### CERTIFICATE OF APPROPRIATENESS

**Property:** 7514 Glenheath St, lot 38, block 67, Glenbrook Valley Sec 7 EXTN Subdivision. The property includes a one-story single-family residence and a detached garage situated on a 12,177 square foot interior lot.

**Proposal:** New Construction – Carport

**SITE PLAN  
PROPOSED**

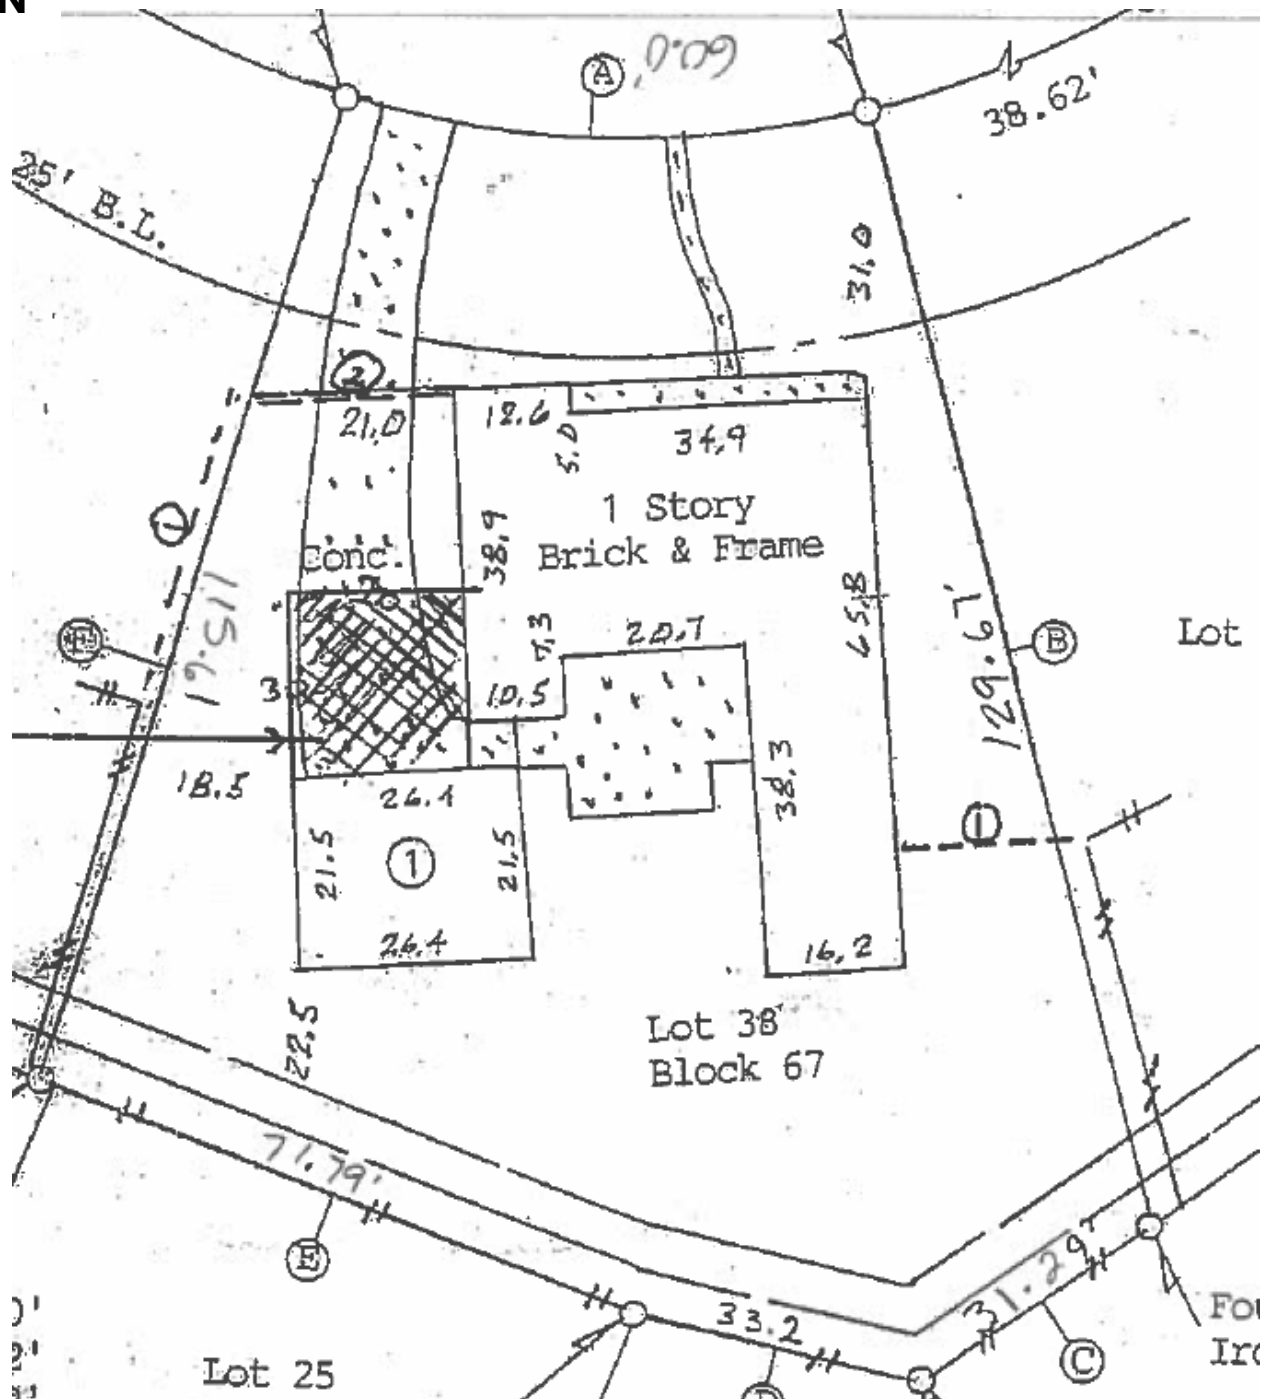
- ☐ ☒ ☐ (1) The distance from the property line of the front and side walls, porches, and exterior features of any proposed new construction must be compatible with the distance from the property line of similar elements of existing contributing structures in the context area;  
*The carport is located in the front half of the lot, most carports are located in the rear half or are original features attached to front of the contributing structure. The carport at 7510 Glenheath next door is located behind the house and in front of the garage.*

- ☐ ☒ ☐ (2) The exterior features of the new construction must be compatible with the exterior features of existing contributing structures in the context area;  
*The carport has a front-gable roof, which is not compatible with other carports in the context area. If the roof were changed to a flat or shed roof, the carport would be more compatible with other carports and less visible.*

- ☐ ☒ ☐ (3) The scale and proportions of the new construction, including the relationship of the width and roofline, overall height, eave height, foundation height, porch height, roof shape, and roof pitch, and other dimensions to each other, must be compatible with the typical scale and proportions of existing contributing structures in the context area unless special circumstances, such as an atypical use, location, or lot size, warrant an atypical scale and proportions;  
*The carport is located above the existing garage and residence eave heights which is not compatible with other carports in the context area. The carport eave should be lowered to be in-line with the existing garage eave height.*

7514 Glenheath: The application for the Certificate of Appropriateness for an attached  
car port is incomplete and not approveable. However, the incomplete application suggests  
that the carport is at least 10 feet high which is not compatible with the typical  
proportions and scale of existing contributing structures. Additionally, the carport may  
extend over the 5 foot side setback which would be a deed restriction violation.

**Recommendation:** Denial - does not satisfy criteria

**HAHC Action:** Denied
